FACTSHEET

TITLE: USE PERMIT NO. 140, requested by the Kent Seacrest on behalf of Andermatt, L.L.C. and Eiger Corporation, for commercial space not to exceed 940,000 sq. ft., on property generally located at South 84TH Street and Nebraska Highway 2.

LINCOLN CITY/LANCASTER COUNTY PLANNING STAFF REPORT

Use Permit #140

Exhibit "A"

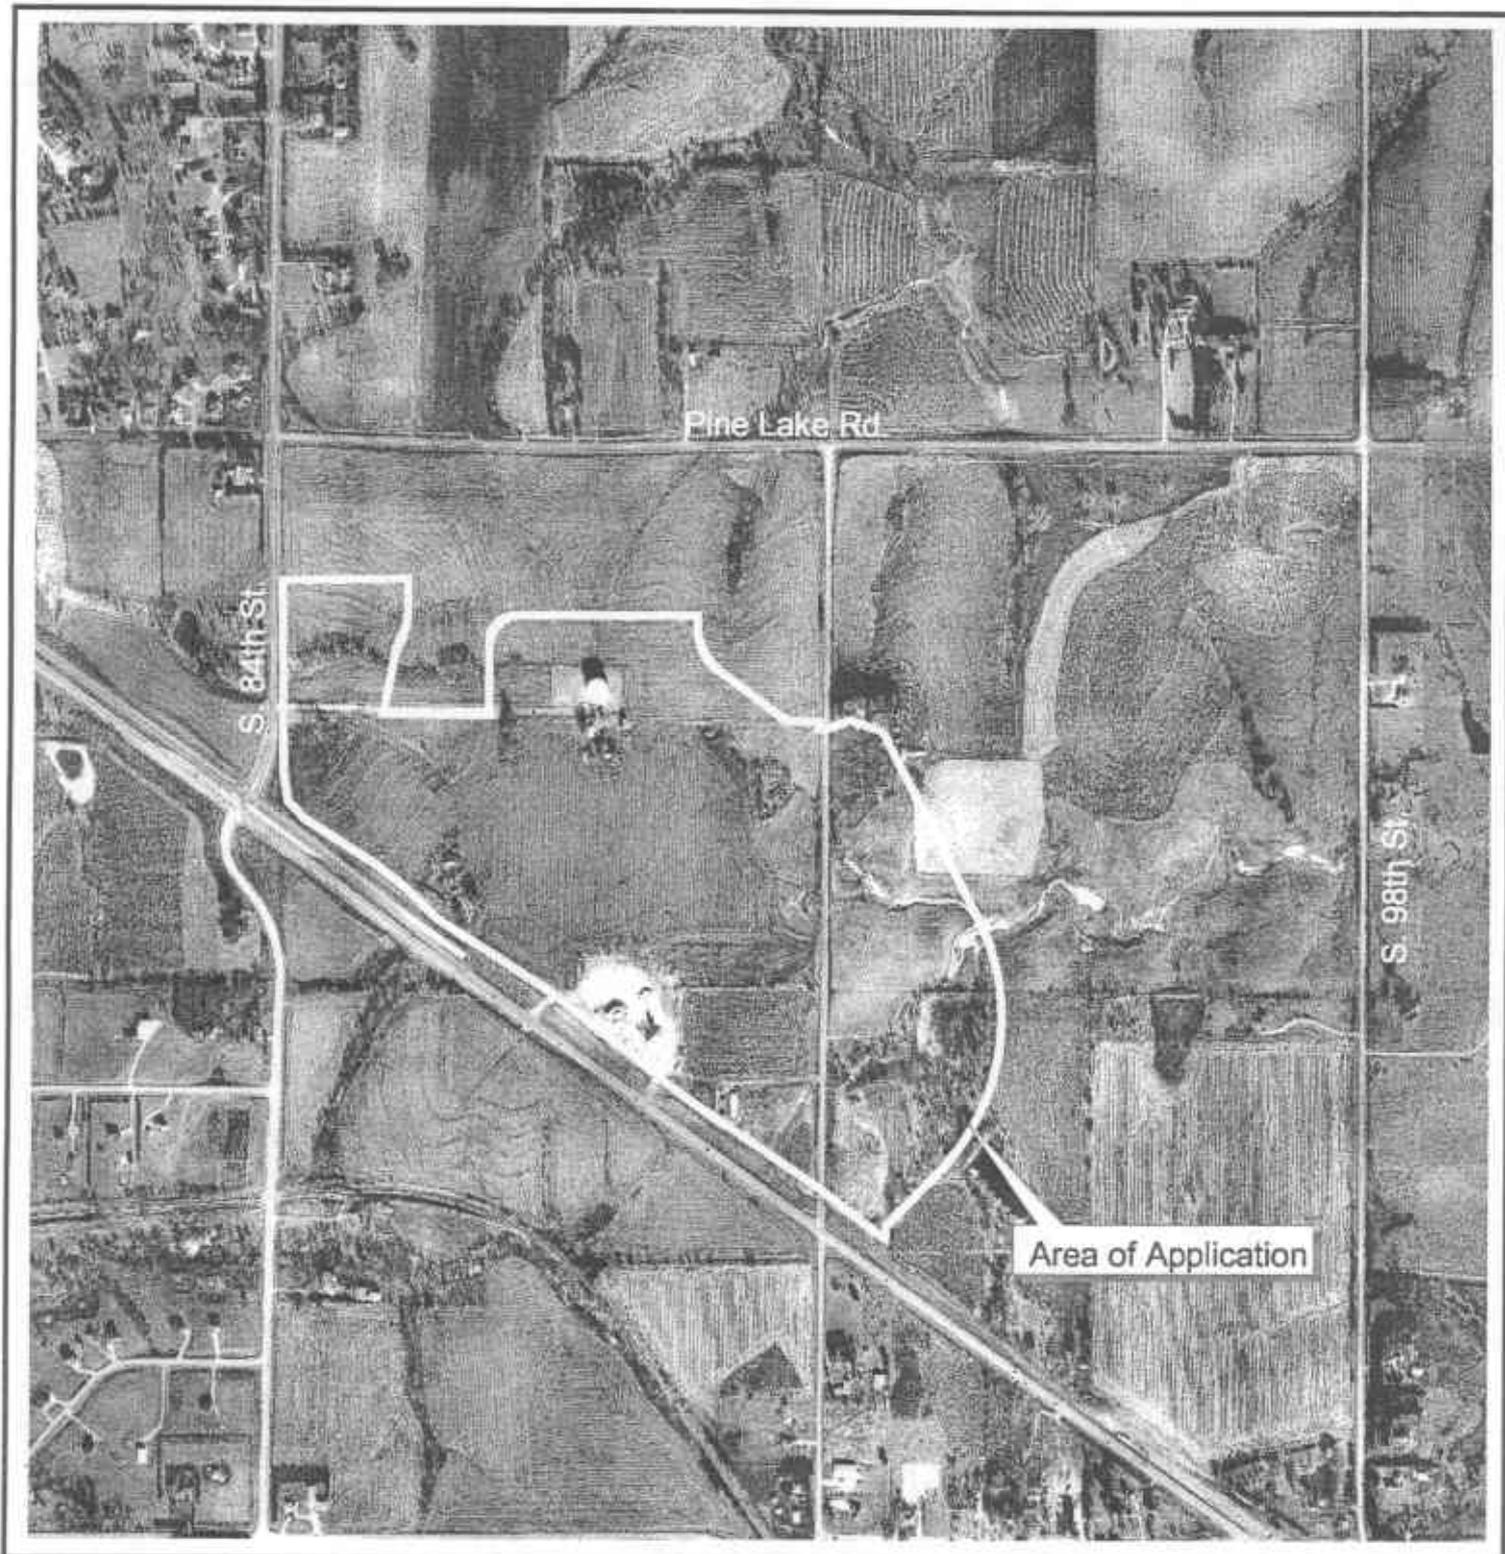
- 1.1.1 Sidewalks along the main driving aisles for Lots 4-6, Block 3 both sides of public streets except for Highway 2 and South 91st Street, one side of private roadways in accordance with a cross-section approved by Planning and Public Works Departments, as well as additional pedestrian ways that connect the buildings to the sidewalk system, as shown on Exhibit "A" attached hereto. Sidewalk crossing points shall be located outside of the curb radius. (**Per Planning Commission at the request of the applicant, with additional language proposed by staff, 9/19/01**)

With regard to the proposed amendments to the conditions of approval, Reynolds agreed with the amendment to Condition #1.1.1 regarding sidewalks; however, the staff would recommend additional language, "Sidewalk crossing points shall be located outside of the curb radius". This will provide a shorter walking distance for the pedestrian.
